SOLANO COMMUNITY COLLEGE  KITCHELL MADI ARCHITECTURE + PLANNING	ADDENDUM #01
	Project: #16 – 007A Solano Community College District Horticulture Site Improvements
	Date: June 27, 2016

- ITEM 1: REVISED Sheet A2.5A (Farmers Stand)
DELETE Sheet A2.5A issued with bid and replace with **REVISED** Sheet A2.5A attached with this Addendum

- ITEM 2: REVISED Sheet A2.3A (Greenhouse)
DELETE Sheet A2.3A issued with bid and replace with **REVISED** Sheet A2.3A attached with this Addendum

- ITEM 3: REVISE Sheet FM-01 (Greenhouse)
DELETE Sheet FM-01 issued with bid and replace with **REVISED** Sheet FM-01 attached with this Addendum

A2.5A
© 2015

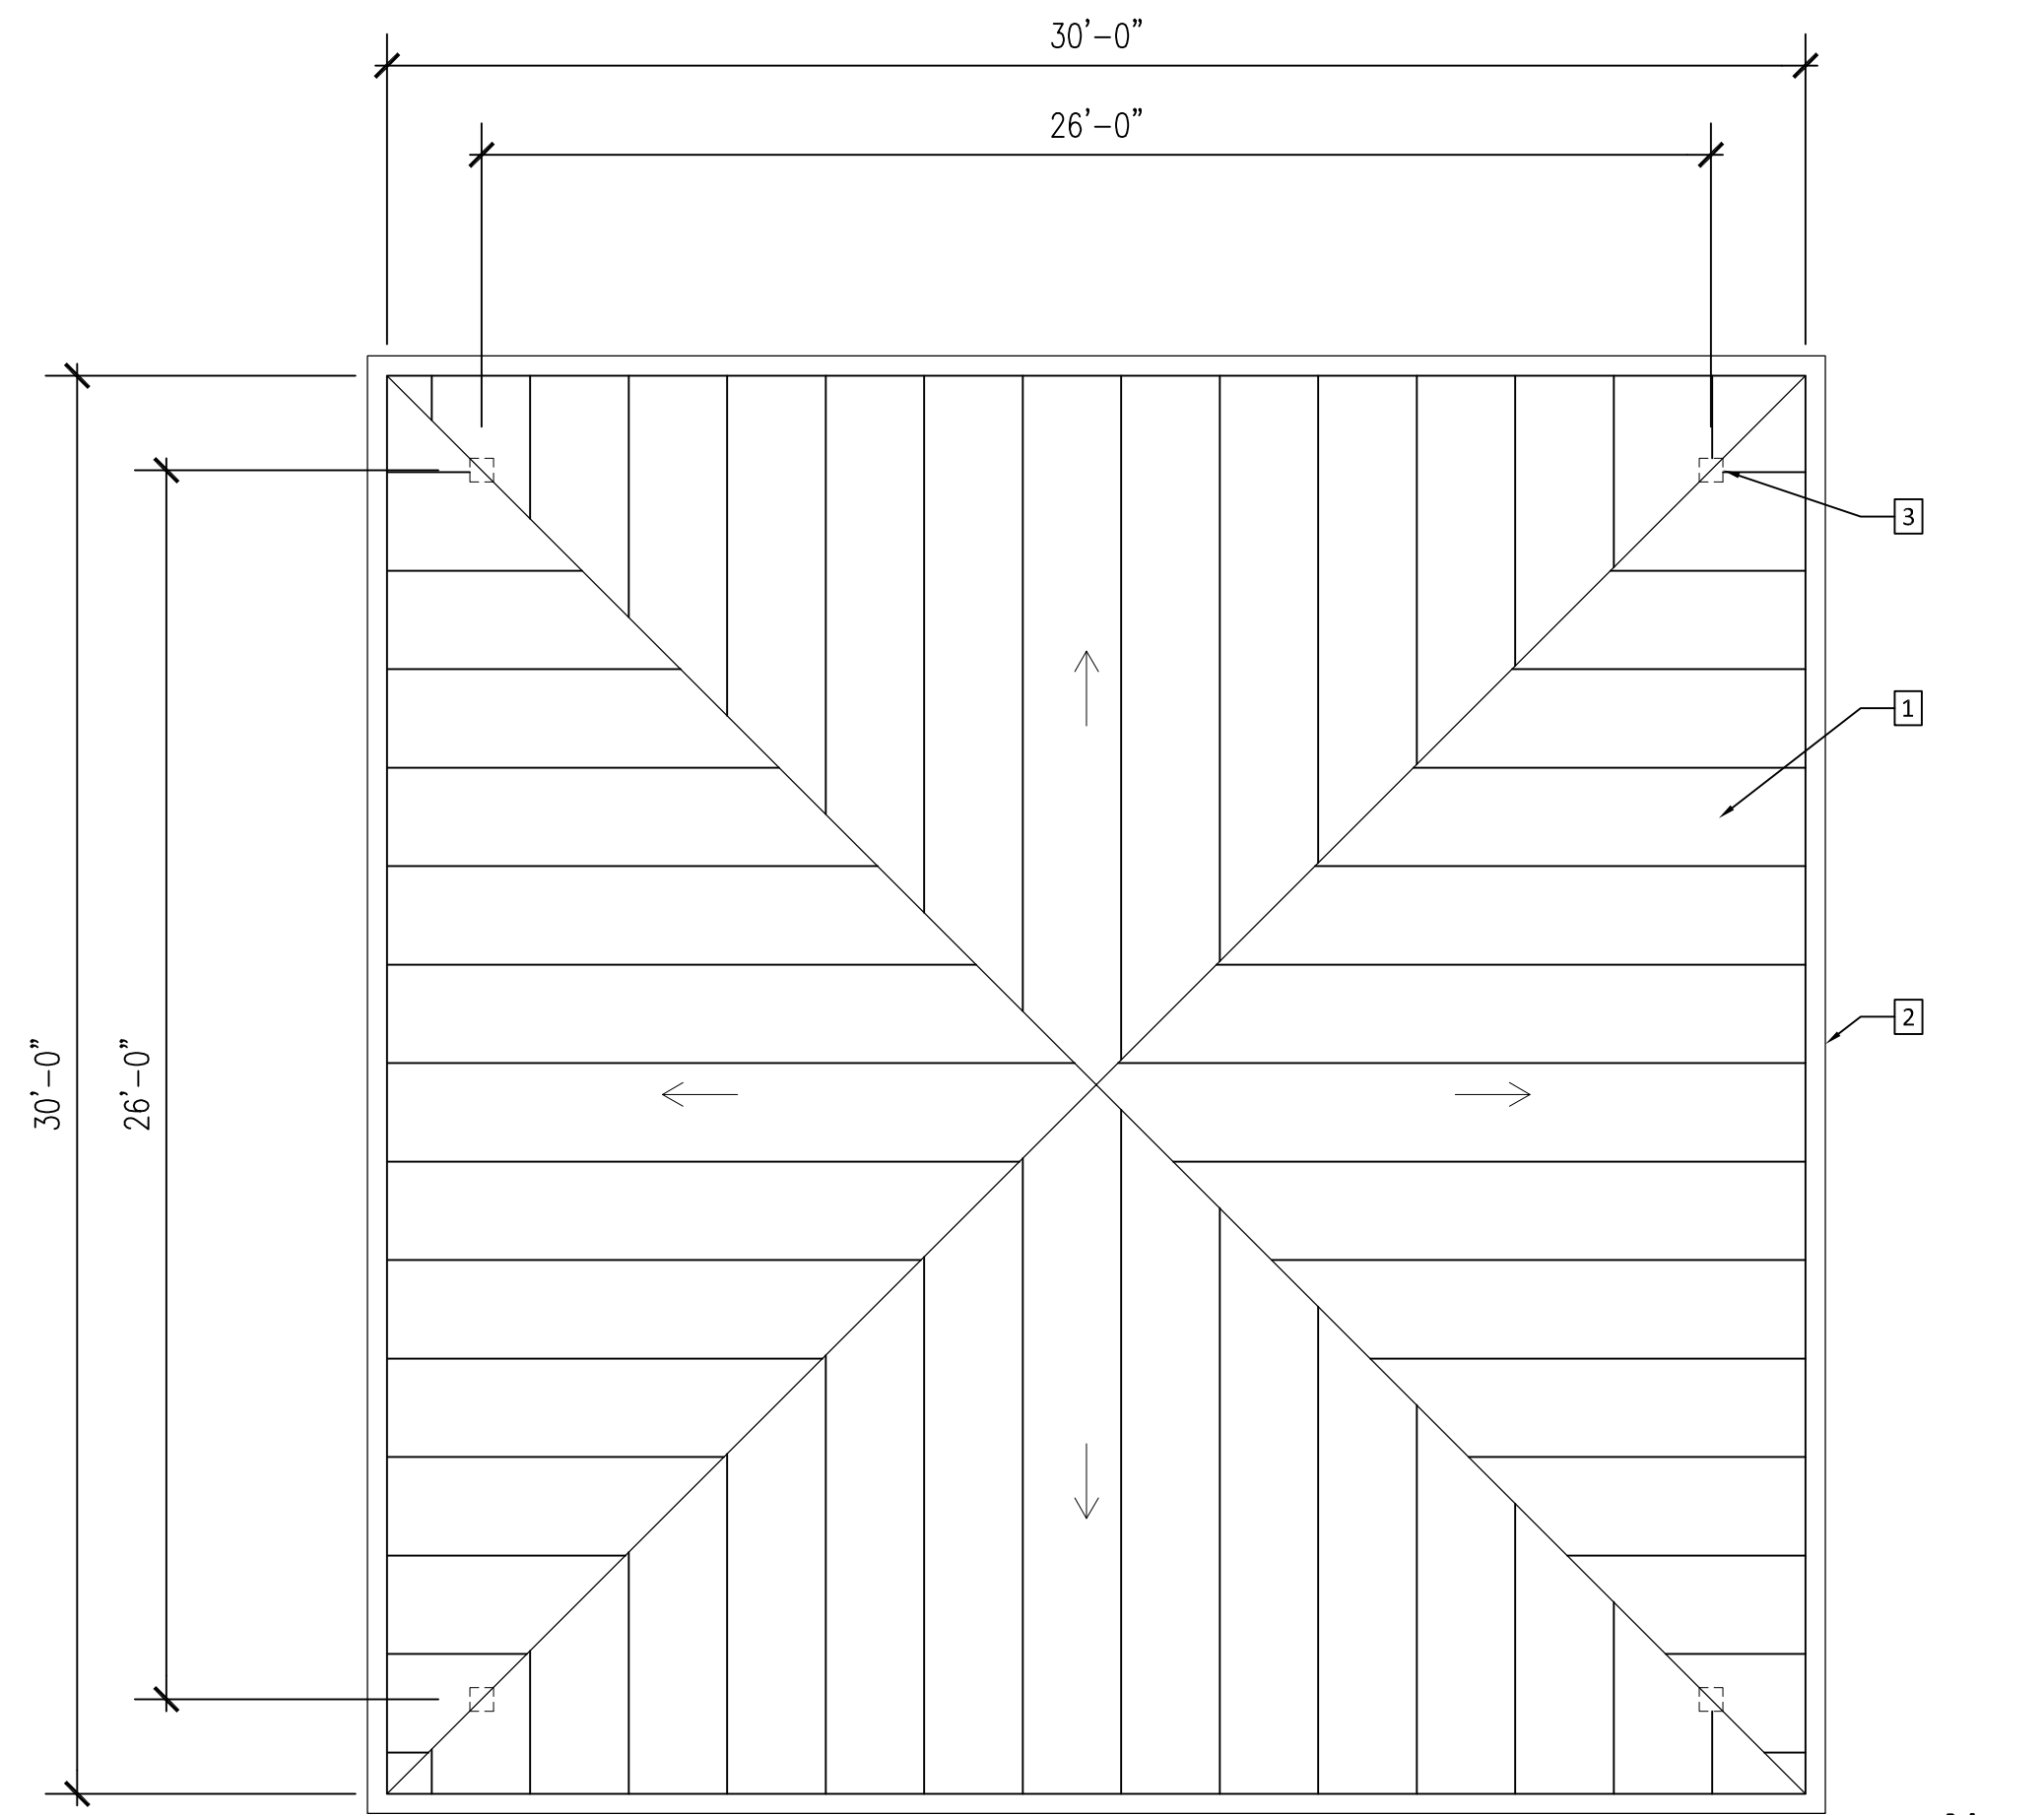
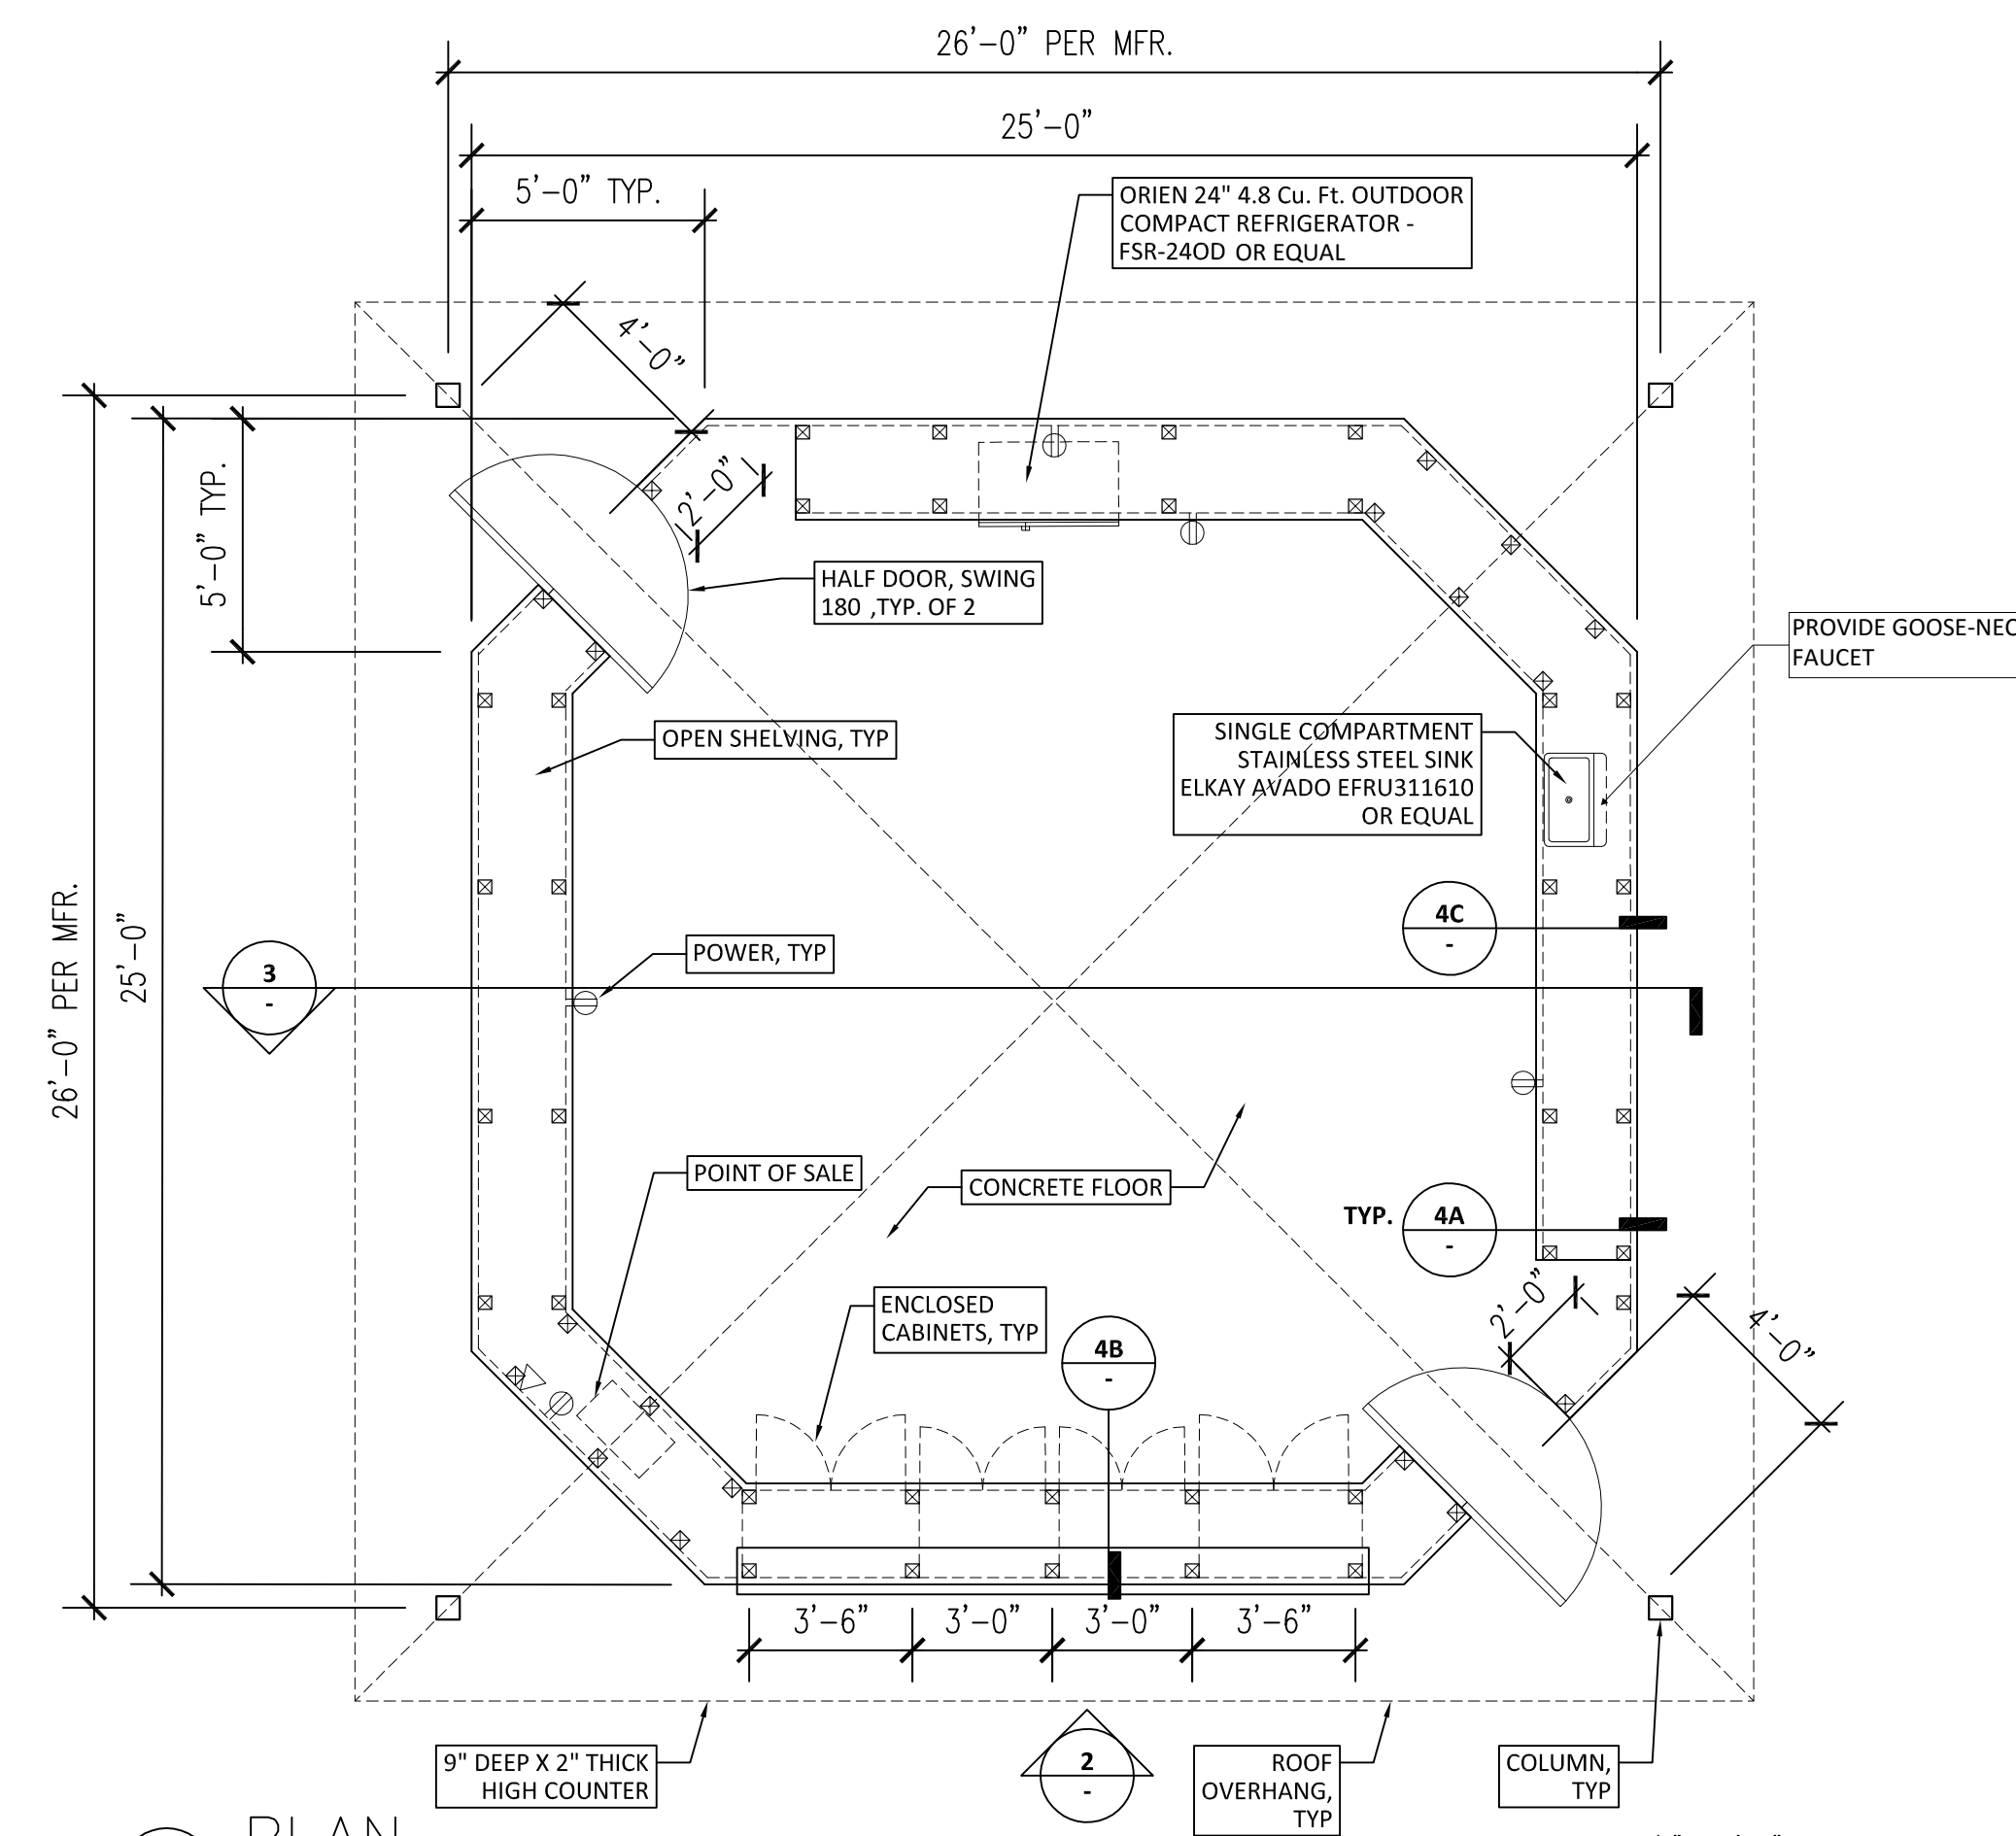
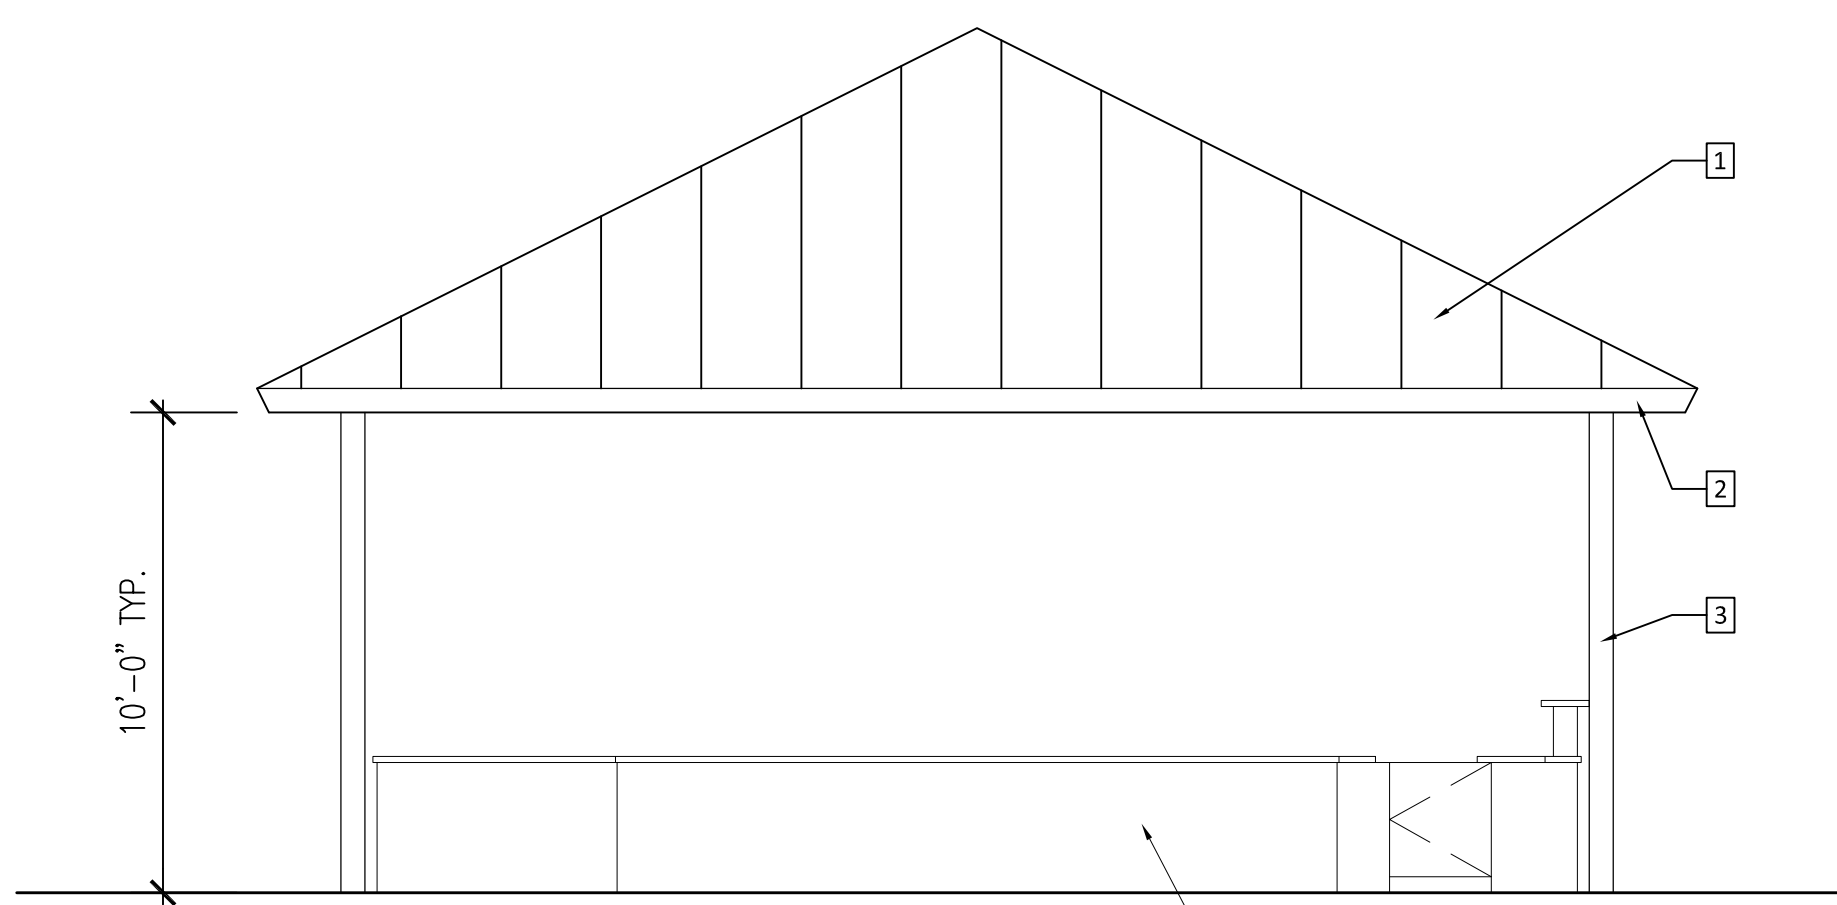
- 2. The description of alternate #2 mentions appliances. Please provide specification on the appliance(s) we are to include in this alternate.**

15. What is the gauge and finish of the stainless steel counter tops? Or please provide a specification.

16. Keynotes 8,9,10 are not defined on A2.5A yet 9 and 10 are called out. Please define.

17. No keynotes beyond 7 are defined however there are call outs for numbers beyond 7. Please define them.

A: See Section B, ITEM 1

A. See Section B, Item 1 for clarification on stainless steel counter tops

A. See Section B, ITEM 1

A. See Section B, ITEM 1
